N1094B-01

Modification Recommended Service Note

N1094B DCA-M Sampling Oscilloscope (Quad Electrical Channel)

Figure 1 Updated overlay - should say 1.4 Vpp Max

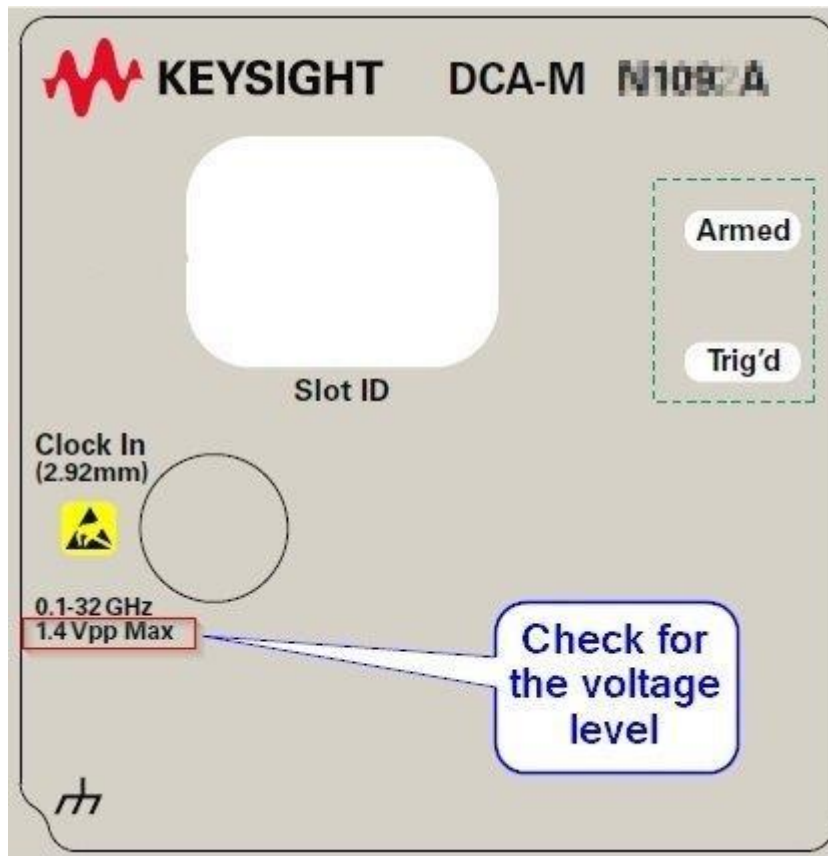
In May 2018, the clock's input port maximum signal voltage changed from 2.0 Vp-p (old value) to 1.4 Vp-p (new value). This is very sensitive circuitry and this change provides additional margin to reduce risk of damage to the instrument.

New instruments shipping after this change has the new left front panel overlay with this updated information, see Figure 1 below.

If the front left panel overlay shows 2 Vp-p (old value), remove the old overlay and replace it with the new overlay that shows 1.4 Vp-p (new value). If the customer has added any asset tags, or other customer information to the old left front panel overlay, it is recommended to send back the old overlay to the customer after it has been removed.
